Permit No: 0507072

Site Address: 241 HAGGIN AV SAC

Nature of Work: 288 SF DETACHED GARAGE-WOOD FRAMED

**City of Sacramento  
Development Services Department  
PLANNING REVIEW FOR BUILDING PERMIT SUBMITTAL**

**CIRCLE THE DRAWING NUMBER BELOW THAT BEST ILLUSTRATES THE EXISTING CONDITION AT THE LOCATION OF THE PROPOSED DRIVEWAY OR SITE ACCESS.**

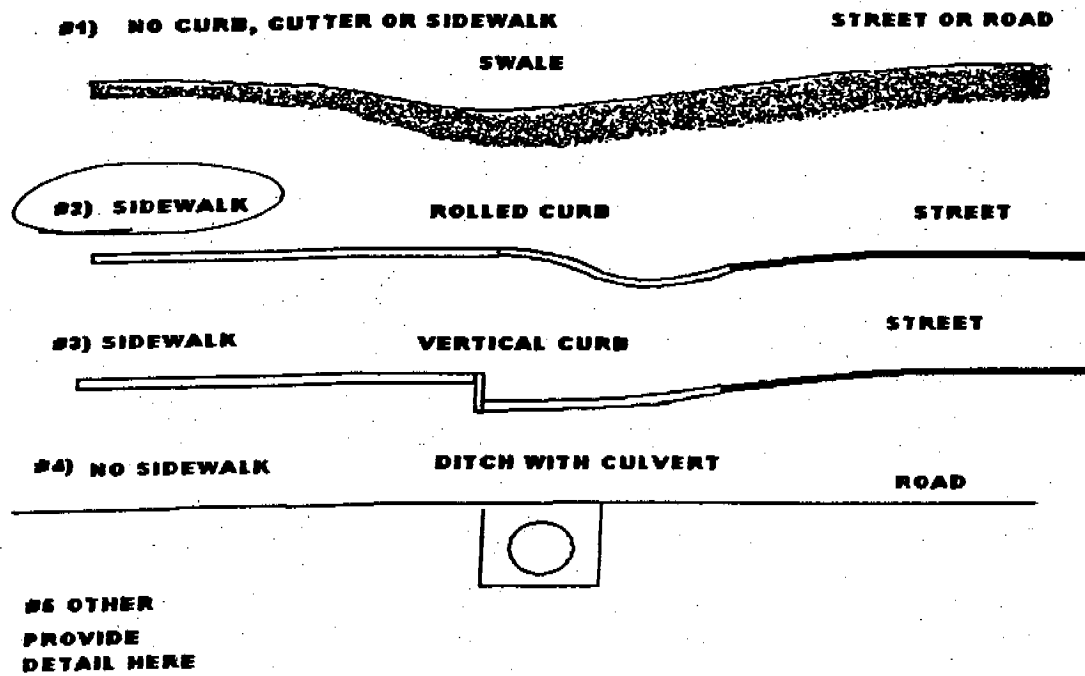
*Site verify drainage to street. MAB*
